Charlotte Department of Transportation

Memorandum

Subject: Rezoning Petition 13-085: Approximately 89.5 acres located on the east side of Providence Road between Golf Links Drive and Chancelot Lane.

Figure 1

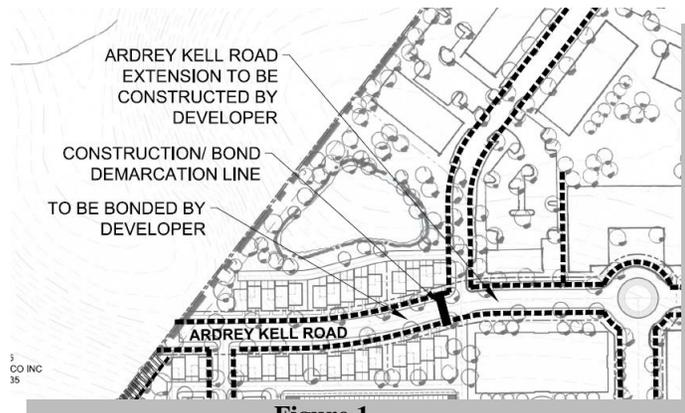
1. We request the petitioner clarify/specify why they are not proposing to construct all of Ardrey Kell Road to the northernmost property line. Not having this connection in place can have an adverse effect on the effectiveness of the internal street network (Figure 1). Furthermore, we request Ardrey Kelly be constructed to the northernmost property line as a part of the current rezoning petition.

Figure 2

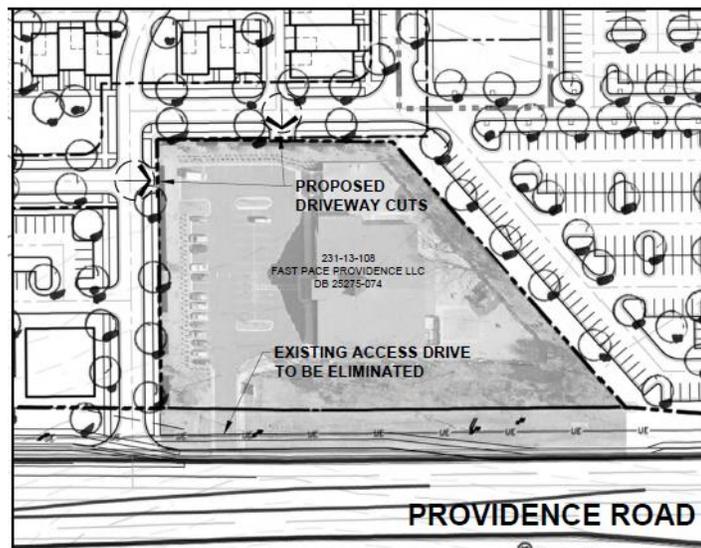
2. The location of the back of curb for Ardrey Kell Road should be 29.5' from the centerline of the street. This curb location will allow Ardrey Kell to be designed consistent with the Urban Street Design Guidelines for an Avenue. We recommend the development standards include this back-of-curb location.
3. We request the petitioner revise the first bullet under Transportation note "D" to the following; "Install a full-movement traffic signal upon meeting applicable MUTCD signal warrants. A signal warrant analysis will be submitted upon completion of Development Area "A".
4. We request the petitioner clarify the status of any existing/proposed cross-access agreement between the proposed development and the existing childcare facility (parcel #23113108). It is our understanding from the owner of parcel #23113108 that a cross access agreement has not been finalized (Figure 2).
